ADDENDUM NO. 2

To the Drawings and Project Manual dated 16 June 2017

**TAS/ADA FIRE MARSHAL
DEFERRED MAINTENANCE PROJECTS
MIDWESTERN STATE
UNIVERSITY**

2 TYPICAL FIRE RISER DETAIL

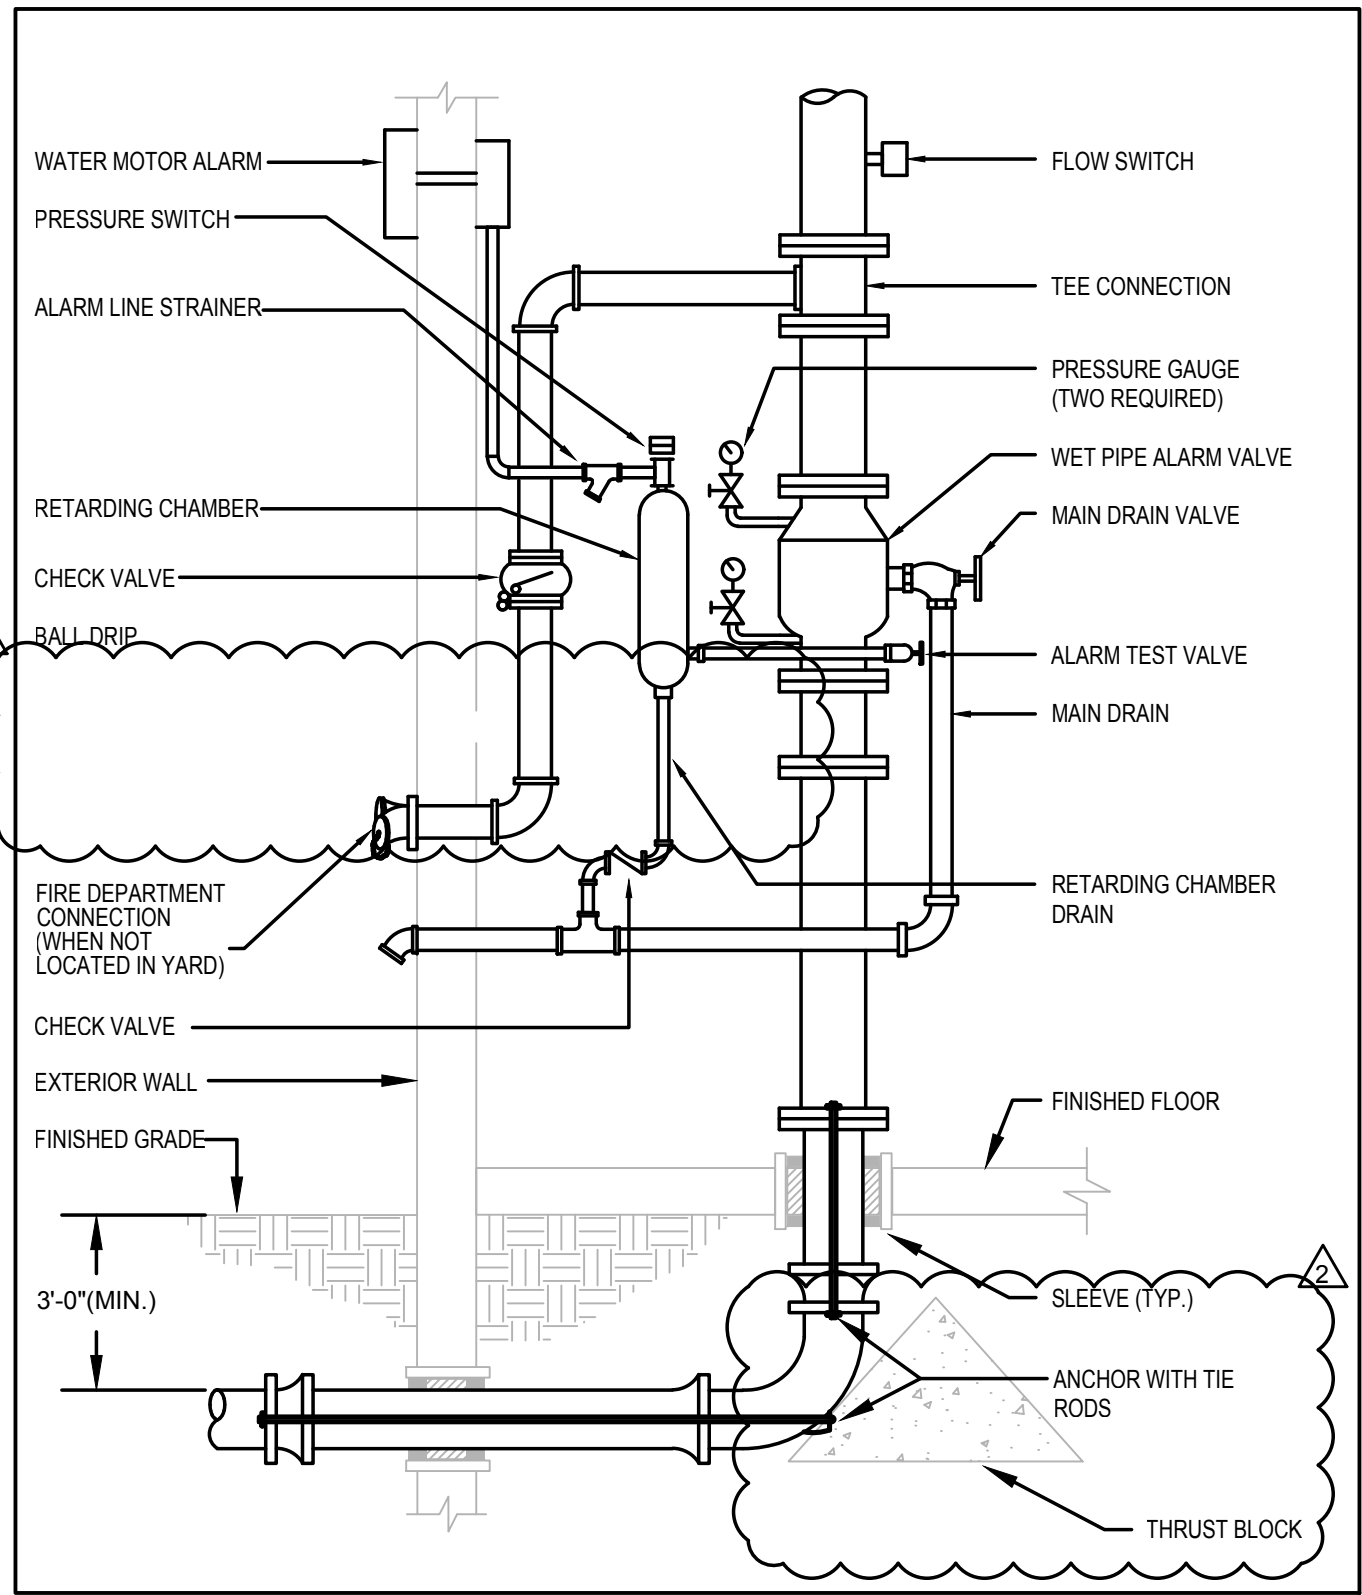
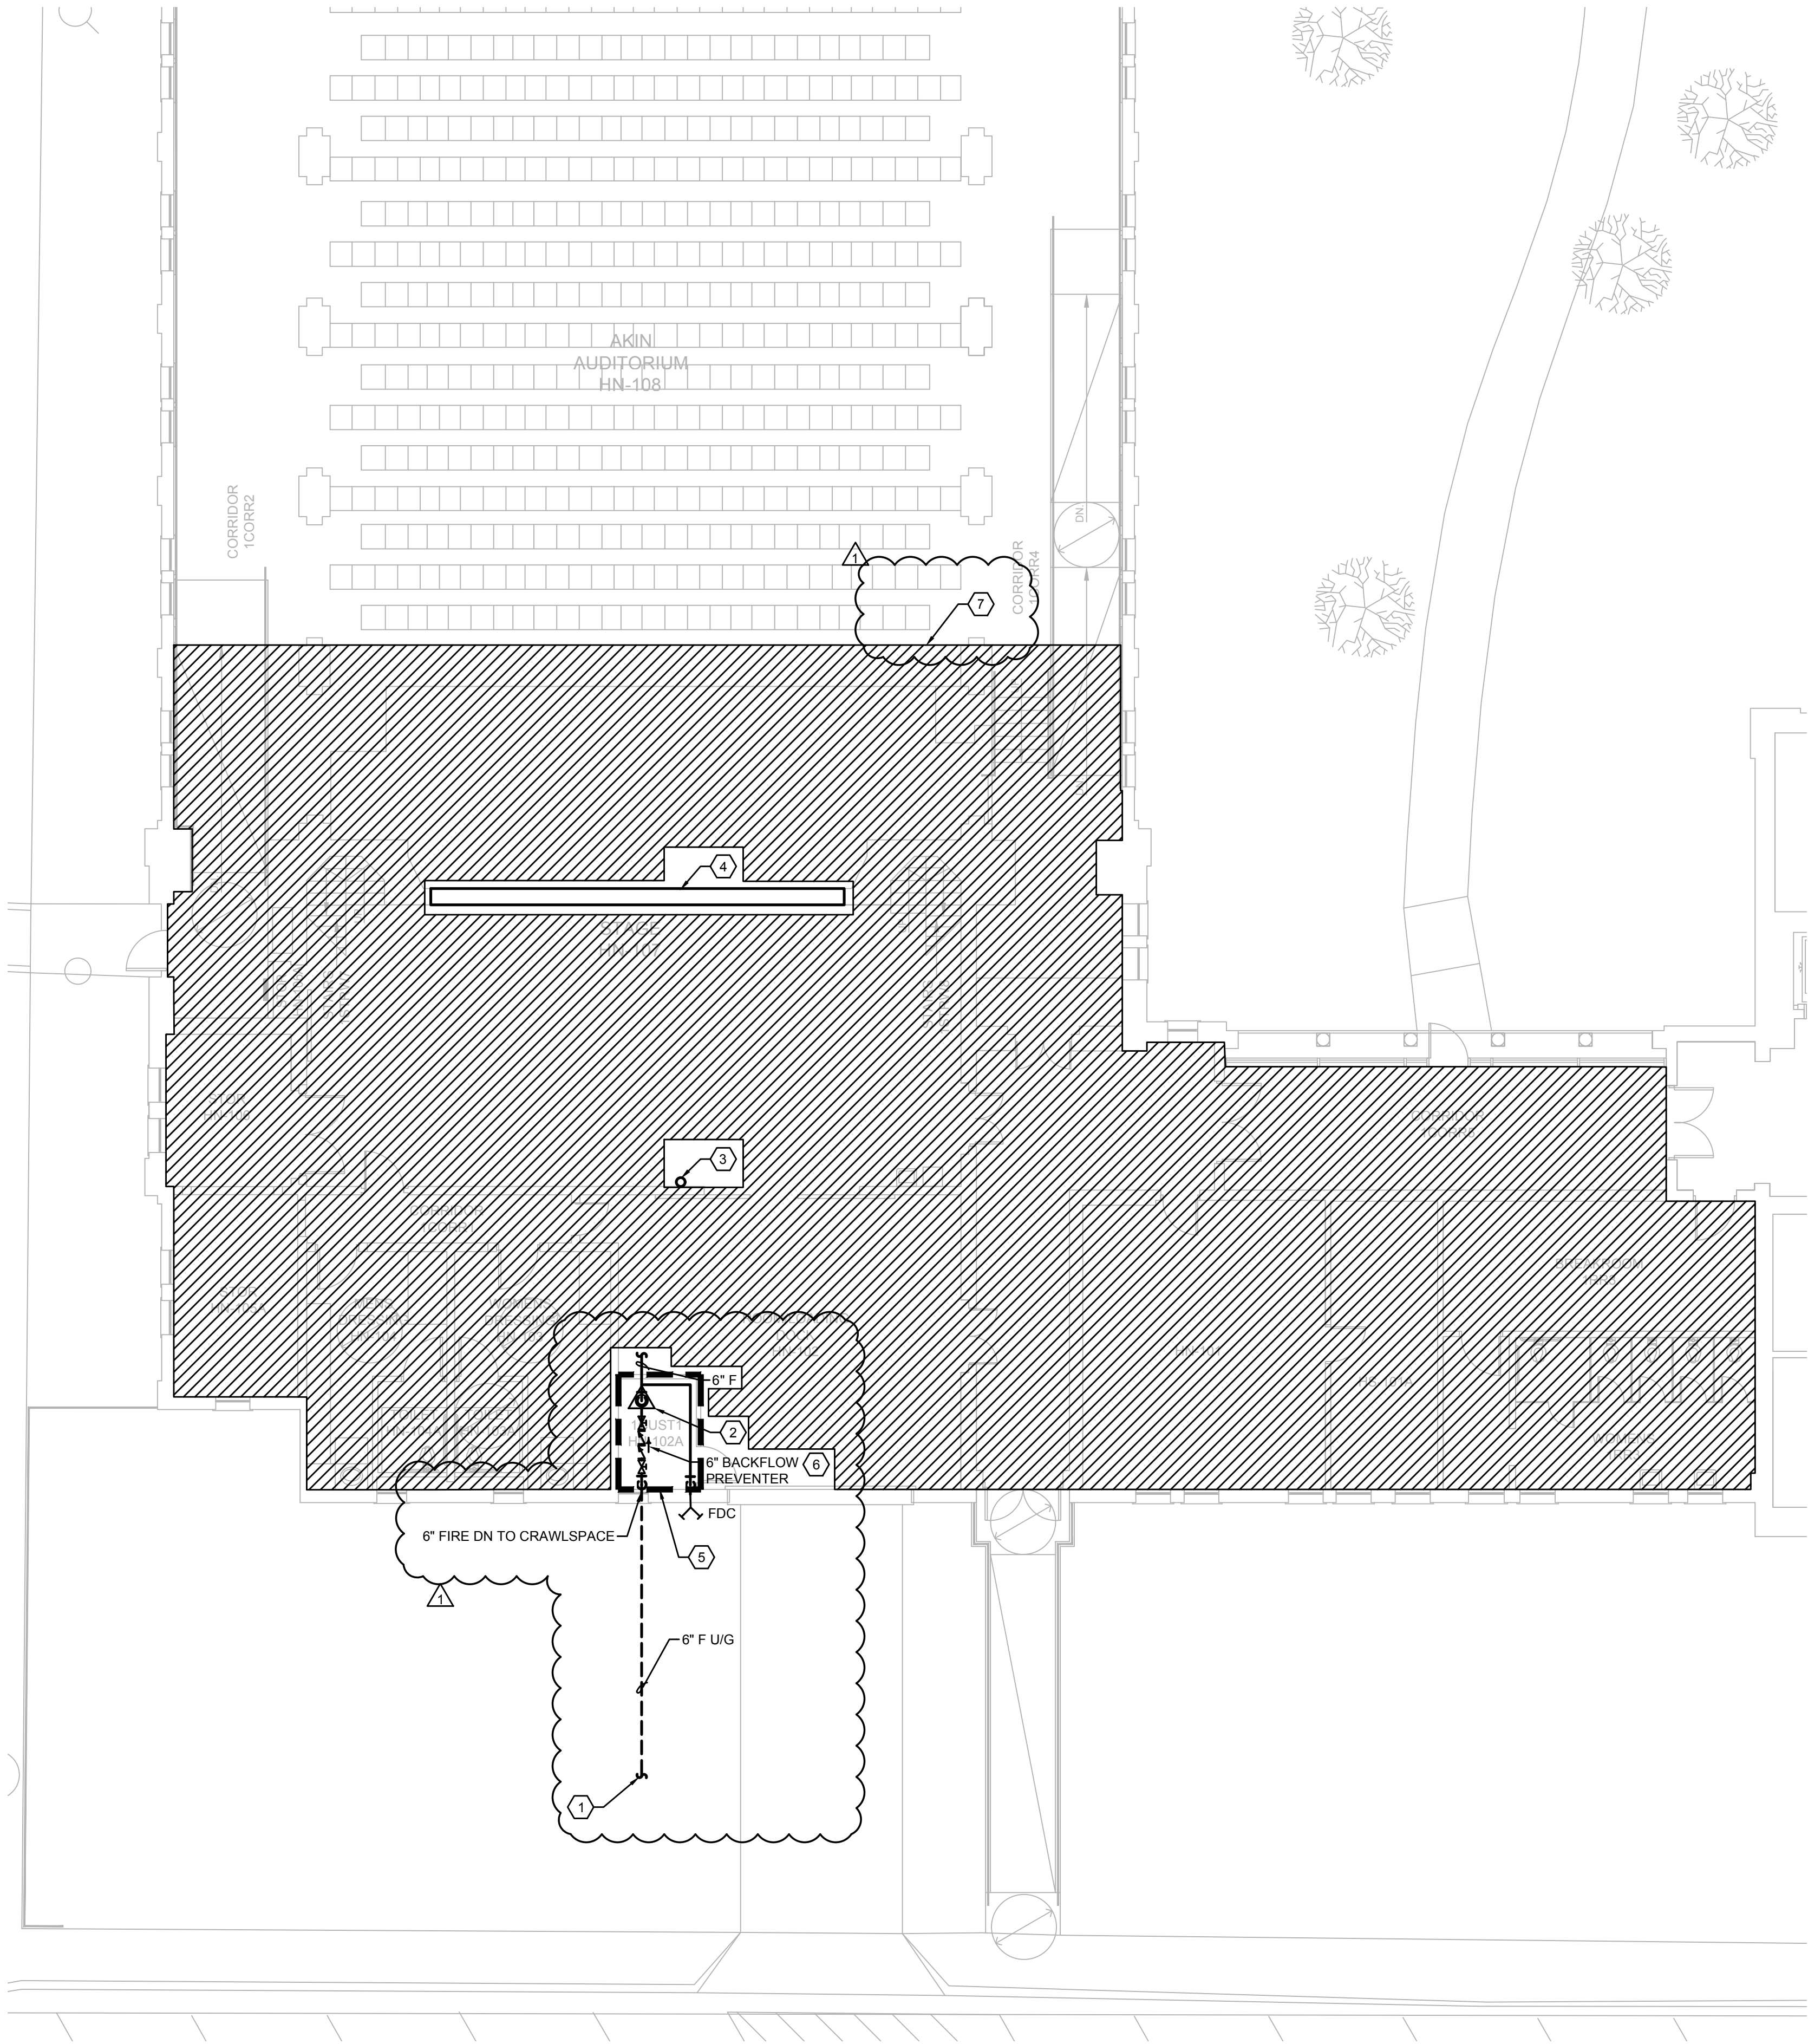
2. Sheet B-FP101 – Revised Drawing as follows:
 - a. Modified Key Notes #1 and #2 to reflect new main size of 6" in lieu of 4". Also, Key Note #1 directs the contractor to insulate the fire piping inside the tunnel and get rid of the heat tracing. It also directs the contractor to coordinate the exact location of tie-ins to water main with MSU Staff.

- b. Modified main size in plans from 4" to 6".
 - c. Remove post indicator from detail 2/B-FP101.
3. Sheet H-FP101 – Revised Drawing as follows:
 - a. Modified Key Notes #1 and #2 to reflect new main size of 6" in lieu of 4". Also, Key Note #1 directs the contractor to coordinate exact location of tie-ins to water main with MSU Staff.

- NEW FIRE 6" RISER TO SERVE CORRIDOR 1CORR1 AND FUTURE EXPANSION OF THE FIRE SPRINKLER COVERAGE IN THE BUILDING. REFER TO DETAIL 2/B-FP101. THE LOCATION OF THE FIRE RISER IN THIS SPACE IS DIAGRAMMATIC IN NATURE AND CONTRACTOR HAS OPTION TO ALTER FIRE RISER LOCATION IN THIS SPACE AS NEEDED.
